Amendments to the Drawings:

REMARKS

III. Drawings

For example, as described in paragraph [0004] of JP(A) 11-141565 and as shown in FIG. 11, provided herein below, the maximum joint angle is generally determined by a slide map.

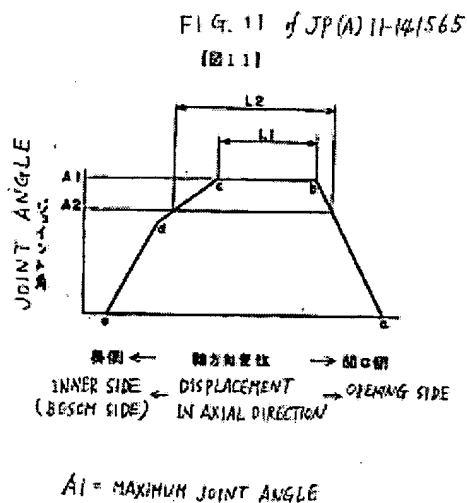
The Examiner has objected to claim 1 for enablement since it recites " θ indicates a required maximum joint angle" and that the Applicant's specification (in paragraph [0028]) only defines the maximum joint angle θ as "the maximum joint angle θ is the maximum value in a joint angle range in which occurrence of the thrust force and vibration caused due to the thrust force are required to be reduced."

The Applicant respectfully submits that the definition of the maximum joint angle, which is known to one having ordinary skill in the art, is the maximum joint angle at which the outer joint member (12) does not interfere with the outer roller (18). In other words, the maximum joint angle is the maximum joint angle at which the outer joint member (12) and the outer roller (18) can take without interference.

In the present invention, the maximum joint angle is determined by the method described in JP(A) 11-141565, and the requirement for joint angle concerning the occurrence of the thrust force and vibration caused due to the thrust force, that is, the maximum joint angle θ of the present invention is determined by subtracting a pre-acquired small value from the maximum joint angle determined by geometry (concerning interference).

Thus, the Applicant respectfully submits that the maximum joint angle determined by geometrical considerations can be determined by technological methods that were known in the art at the time of filing of this patent application.
